Product Change Notice (PCN)

PCN Number: PCN-0374226R-01

- CPE 1785

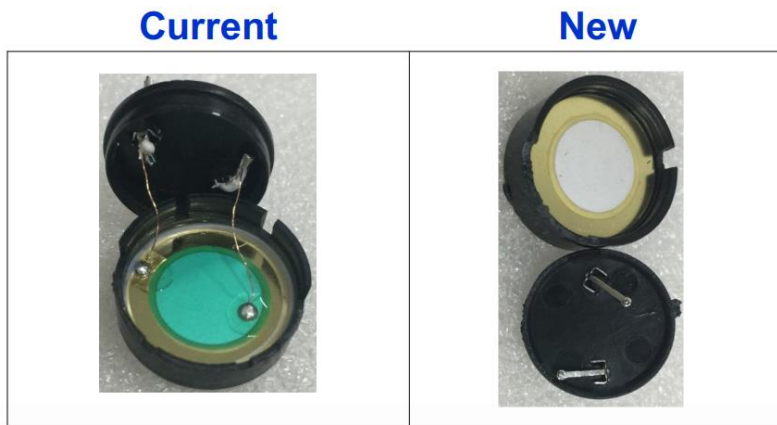
❖ Appearance

- Case markings Change from NORYL case to PBT
- Bottom notches going from 6 to 2

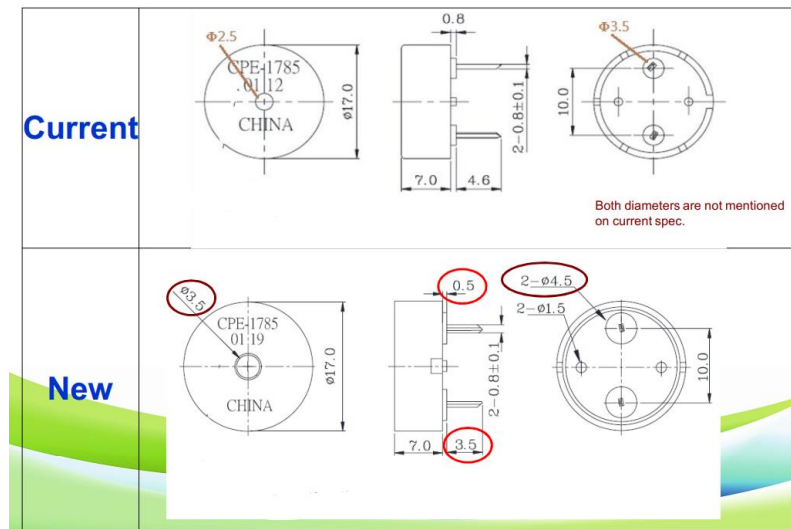
- ❖ **Inside structure**
 - **Change from solder mask on inside to spring contact**

- ❖ **Pin length from 4.6mm to 3.5mm**
